Subject: **Palo Verde Nuclear Generating Station (PVNGS) Units 1, 2, and 3
Renewed Operating License Nos. NPF-41, NPF-51, and NPF-74
Docket Nos. STN 50-528, 50-529, and 50-530
Application for Technical Specification Improvement to Adopt
TSTF-487-A, Revision 1, Relocate DNB Parameters to the COLR**

**Description and Assessment of Proposed License
Amendment**

Proposed Technical Specification Changes (Mark-Up)

Figure 3.4.1-1

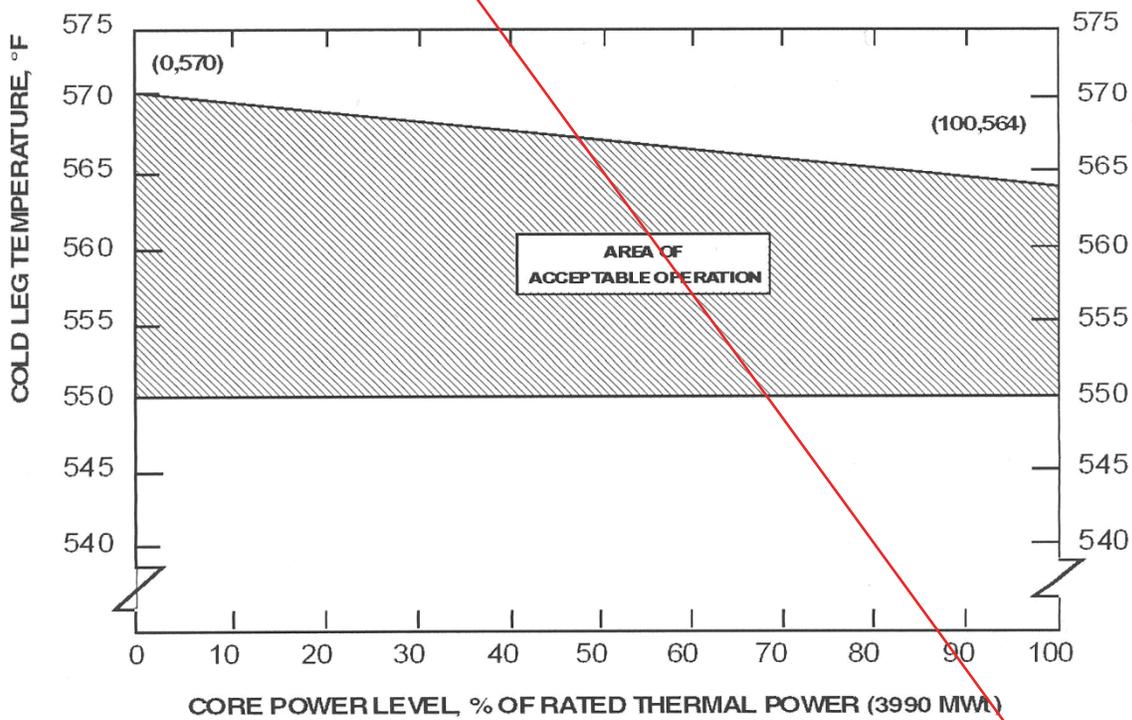
PVNGS Units 1, 2, and 3 TS utilizes Figure 3.4.1-1, *Reactor Coolant Cold Leg Temperature vs. Core Power Level*, to stipulate the area of acceptable operation for reactor coolant system (RCS) cold leg temperature. Figure 3.4.1-1 is included with the conversion to the Improved Technical Specifications (ITS) as documented in License Amendment (LA) 117, dated May 20, 1998 [NRC Agencywide Documents Access and Management System (ADAMS) Accession Number ML021720060]. Figure 3.4.1-1 is being removed from TS 3.4.1 and incorporated into the COLR. TS Bases B 3.4.1 is also revised to describe that the LCO limit is specified in the COLR.

- a. ~~Pressurizer pressure \geq 2130 psia and \leq 2295 psia; and~~
- b. ~~RCS cold leg temperature (T_c) shall be within the area of acceptable operation shown in Figure 3.4.1-1; and~~
- c. ~~RCS total flow rate \geq 155.8 E6 lbm/hour.~~

SURVEILLANCE	FREQUENCY
SR 3.4.1.1 Verify pressurizer pressure ≥ 2130 psia and ≤ 2295 psia.  ←	In accordance with the Surveillance Frequency Control Program
SR 3.4.1.2 Verify RCS cold leg temperature within limits as shown in Figure 3.4.1-1.  ←	In accordance with the Surveillance Frequency Control Program
SR 3.4.1.3 -----NOTE----- Required to be met in MODE 1 with all RCPs running. Verify RCS total flow rate $\geq 155.8 \text{ E}6$ lbm/hour.  ←	In accordance with the Surveillance Frequency Control Program

LCO 3.4.1 RCS DNB parameters for pressurizer pressure, cold leg temperature, and RCS total flow rate shall be within the limits specified in the COLR.

SURVEILLANCE	FREQUENCY
SR 3.4.1.1 Verify pressurizer pressure is within the limits specified in the COLR.	In accordance with the Surveillance Frequency Control Program
SR 3.4.1.2 Verify RCS cold leg temperature is within the limits specified in the COLR.	In accordance with the Surveillance Frequency Control Program
SR 3.4.1.3 -----NOTE----- Required to be met in MODE 1 with all RCPs running. ----- Verify RCS total flow rate is greater than or equal to the limits specified in the COLR.	In accordance with the Surveillance Frequency Control Program

Figure Deleted
